U.S. NUCLEAR REGULATORY COMMISSION  
OFFICE OF INSPECTION AND ENFORCEMENT

Report No. 50-237/79-25; 50-249/79-23

Facility Name: Dresden Nuclear Power Station, Units 2 and 3

Inspection on September 17, 18 and 24-27, 1979 (Report No. 50-237/79-25; 50-249/79-23)

"FIGURE 1"  
DRESDEN STATION &  
COOLING LAKE  
1973

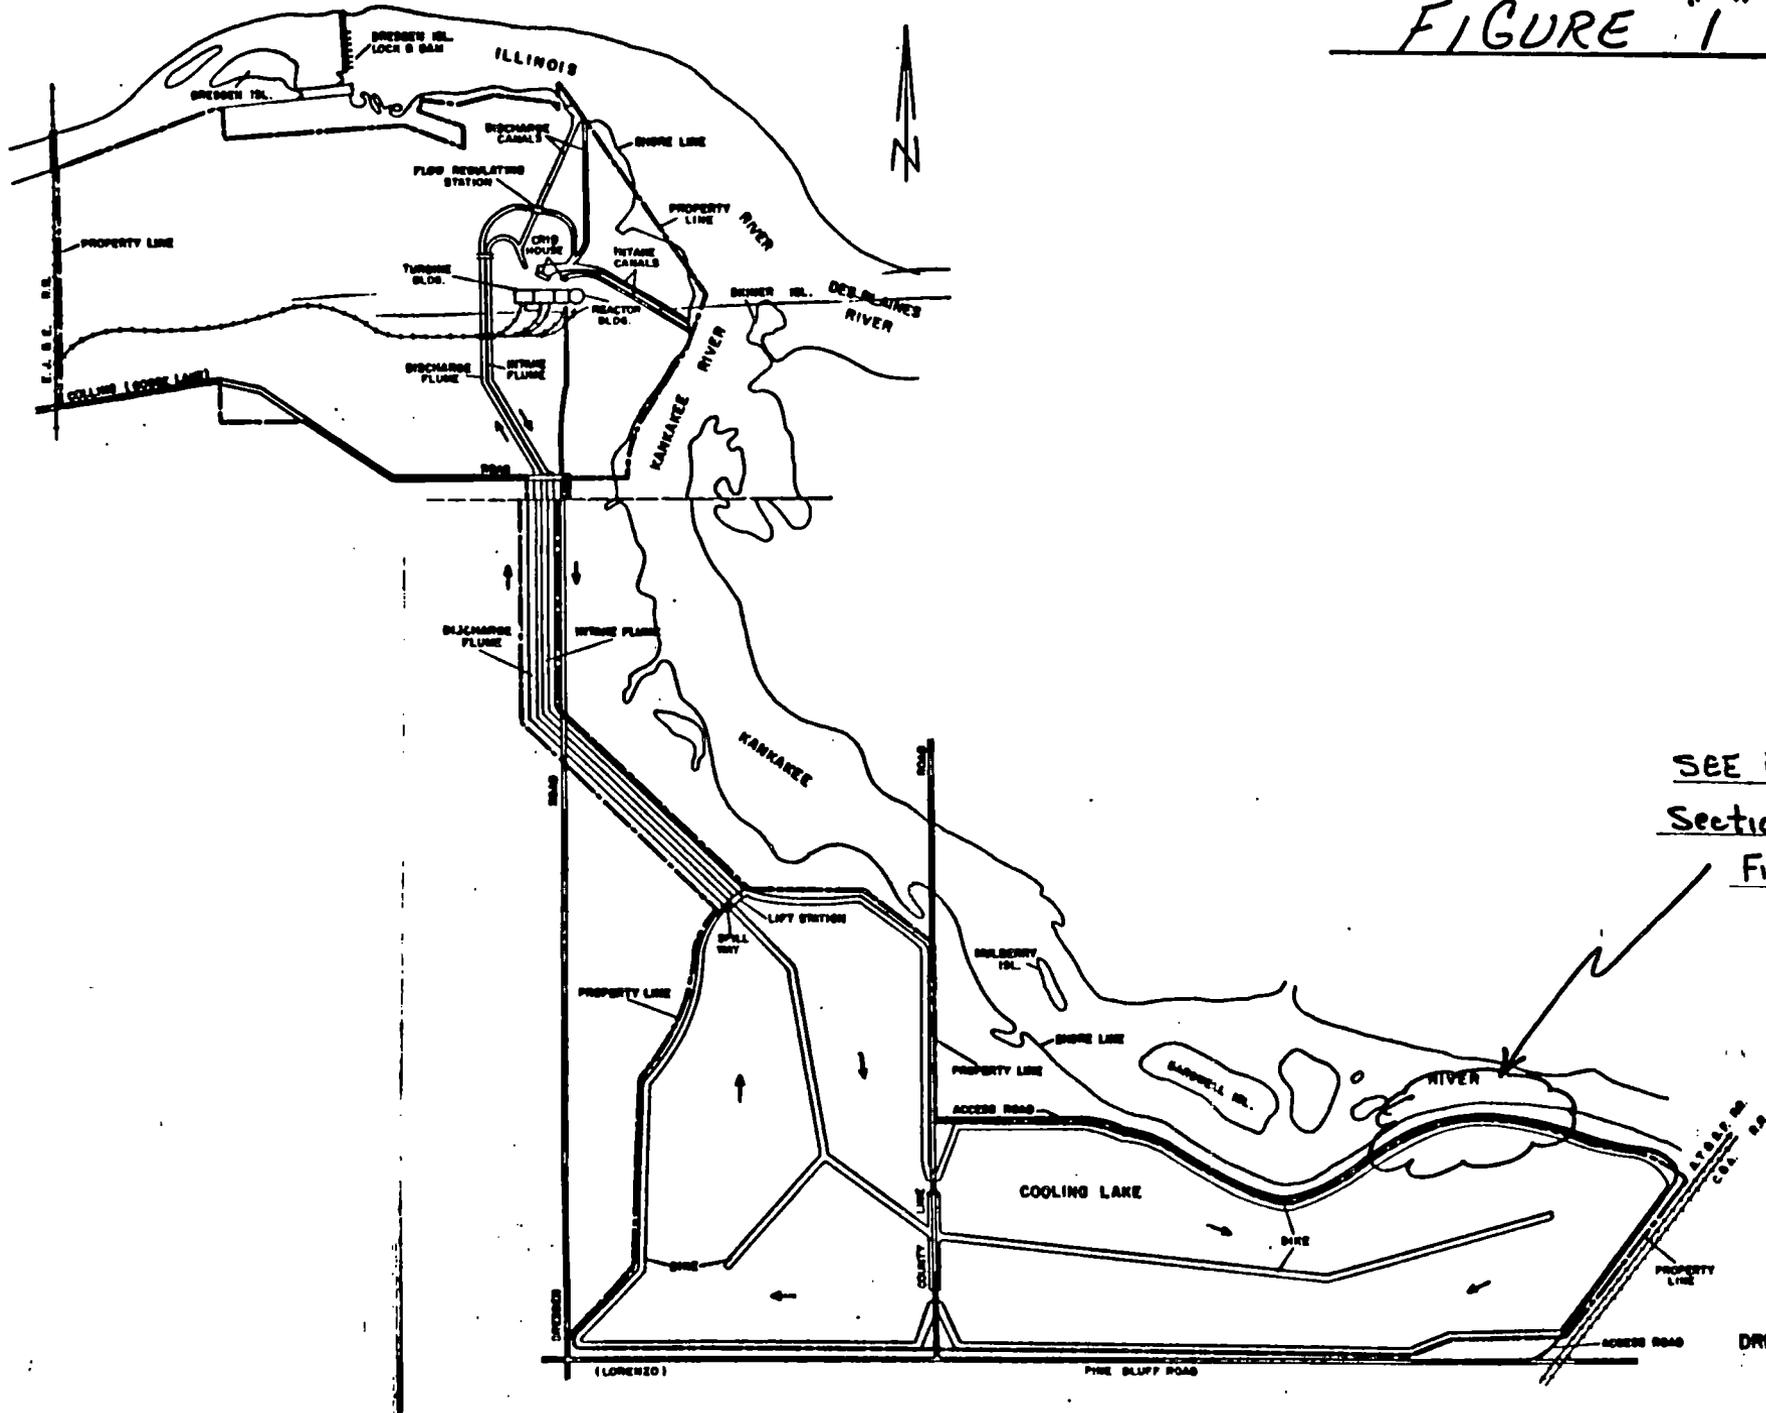
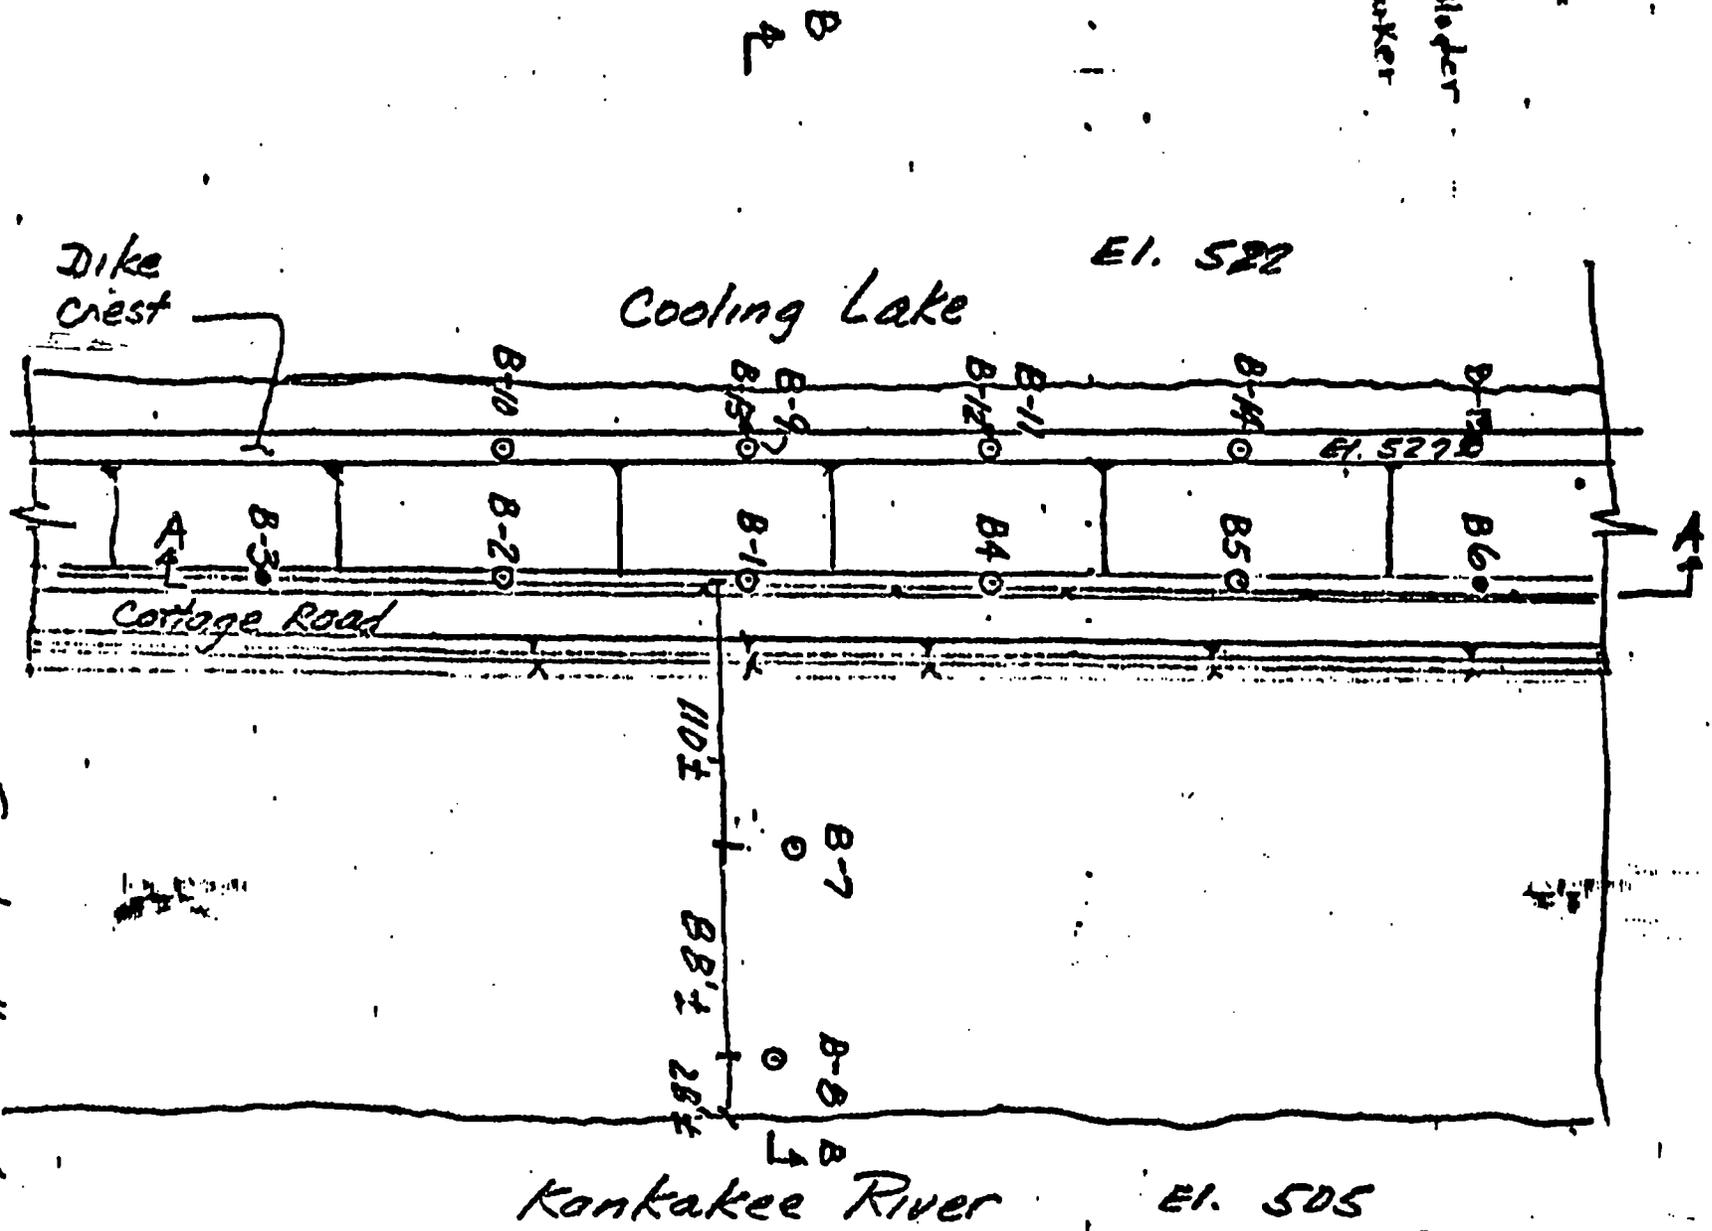
Boring Locations: See attached plan of cooling lake, (Figure 1, 1A and 1B)

Boring Log #1 (Parallel to toe of North Dike) September 24, 1979  
water level in boring two feet below surface

<u>Sample</u>	<u>Depth (Ft.)</u>	<u>Blows per Ft.</u>	<u>Material Description</u>
1	0-1.5	20	Brown clay
2	2.5-4	8	Sand
3	5-6.5	7	Sand and gravel
4	7.5-9	50 per 3"	Sand and gravel
5	10-11.5	-	Blue shale

Boring #2 (Parallel to toe of North Dike) September 24, 1979 water level two feet from surface

<u>Sample</u>	<u>Depth (Ft.)</u>	<u>Blows per Ft.</u>	<u>Material Description</u>
1	0-1.5	26	Brown clay
2	2.5-4	12	Sand and gravel
3	5-6.5	68	Shale

Boring #3 (Parallel to toe of North Dike) September 24, 1979 water level two feet from surface

<u>Sample</u>	<u>Depth (Ft.)</u>	<u>Blows per Ft.</u>	<u>Material Description</u>
1	0-1.5	13	Brown clay
2	2.5-4	47	Clay silt
3	5-6.5	50 for 6"	Clay silt

Boring #4 (Parallel to toe of North Dike) September 25, 1979 water level 3.5 feet from surface

<u>Sample</u>	<u>Depth (Ft.)</u>	<u>Blows per Ft.</u>	<u>Material Description</u>
1	0-1.5	25	Brown clay
2	2.5-4	14	Sand
3	5-6.5	50 for 3"	Shale
4	7.5-9	-	Gray shale

Boring #5 (Parallel to toe of North Dike) September 25, 1979 water level 6.5 feet from surface

<u>Sample</u>	<u>Depth (Ft.)</u>	<u>Blows per Ft.</u>	<u>Material Description</u>
1	0-1.5	42	Brown clay
2	2.5-4	15	Sandy clay
3	5-6.5	8	Sand and gravel
4	7.5-9	11	Sand and gravel
5	10-11.5	50 for 6"	-

Boring #6 (Parallel to toe of North Dike) September 25, 1979 water level five feet from surface

<u>Sample</u>	<u>Depth (ft.)</u>	<u>Blows per Ft.</u>	<u>Material Description</u>
1	0-1.5	13	Sandy clay
2	2.5-4	16	Brown sand (dry)
3	5-6.5	11	Sand and gravel (wet)
4	7.5-9	14	Sand and gravel (wet)
5	10-11.5	31	Sand and gravel (wet)
6	12.5-14	50 for 6"	Gray shale

Borings #7 and #8 (between North Dike and river bank) September 26, 1979  
 No data available at time of report.

Borings #9, #10 and #11 (Centerline of North Dike) September 27, 1979  
 No data available at time of report.

NOTE: Boring #11 indicated sand and gravel 29 feet to 34 feet from top of dike - loss of water noted from boring casing on the order of five inches per four minute estimated by Harza Engineering.
